24 Mansionhouse Road EH9 2JD

Planning Applications 21/01731/FUL and 21/01732/LBC

OBJECTION from Grange Association

4 May 2021

21/01731/FUL: Corrected ground floor plan (Opt 2): (Courtesy of applicant's agent)

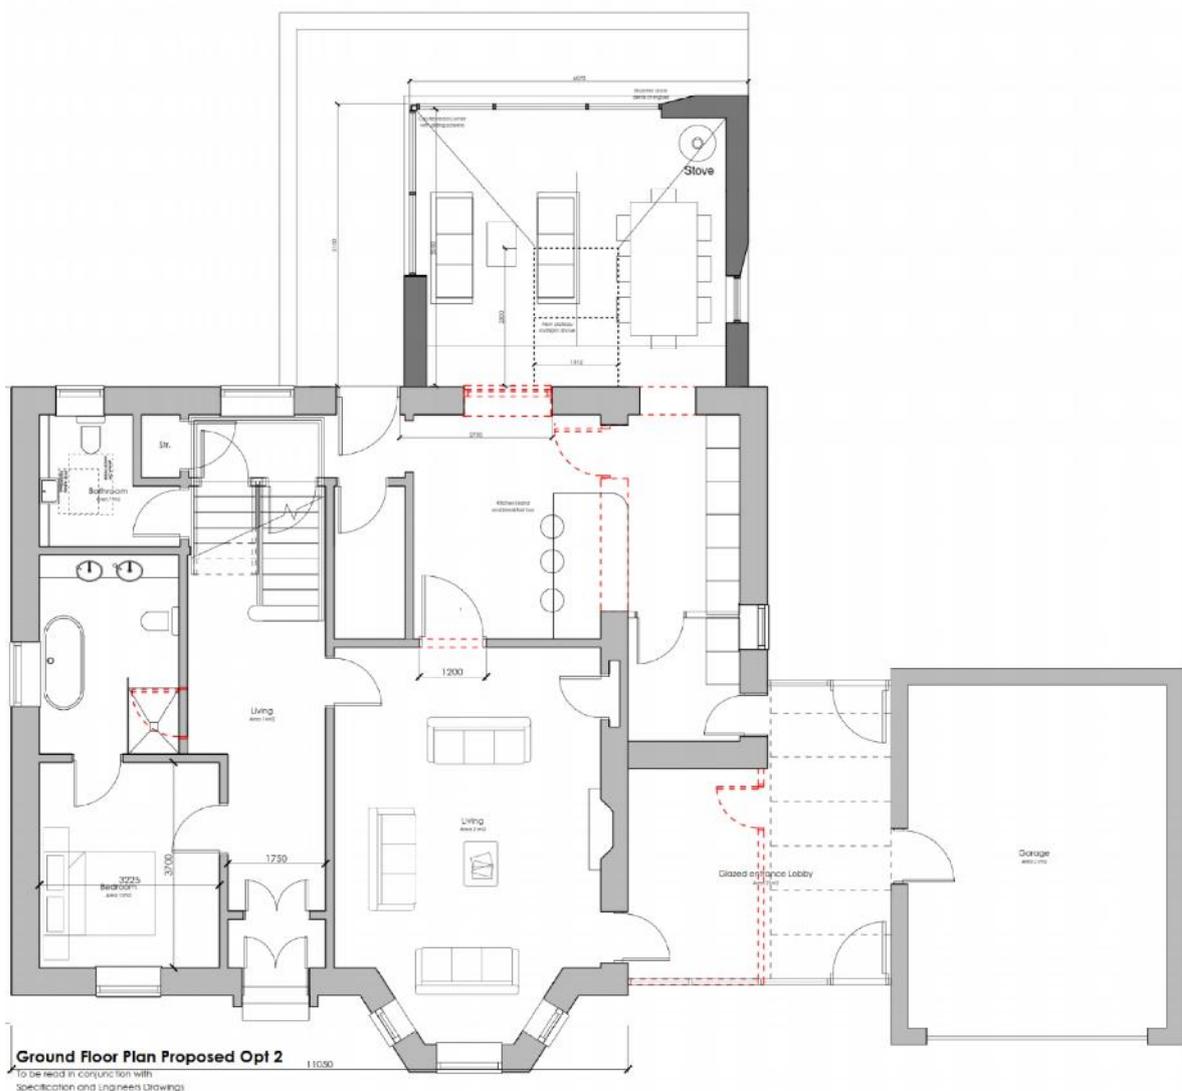
The documents uploaded to the planning portal do not include a plan view of the proposals. The applicant’s agent, however, has provided us with a corrected copy of the plan, for which we are grateful, showing the proposed glazed link in line with the villa’s principal elevation. (The bay window and the non-original garage do not define the principal elevation.)

Our objection relates to both the form and the materials of the proposed side extension. The form is inappropriate because it is not behind the principal elevation and would *'[interfere] with oblique views of the listed building and [disrupt] formal approaches'*. It would create a terraced effect, uncharacteristic of the area. The materials are inappropriate for a listed Victorian villa, with full width glazing to ground level. The expanse of glazing would be an alien intrusion into the street with its characterful listed villas. The materials for the roof are not specified. The corrected plan view shows seven panels to the roof but the construction and materials remain unclear.

We request that the application for the side extension ("glazed link") be refused.
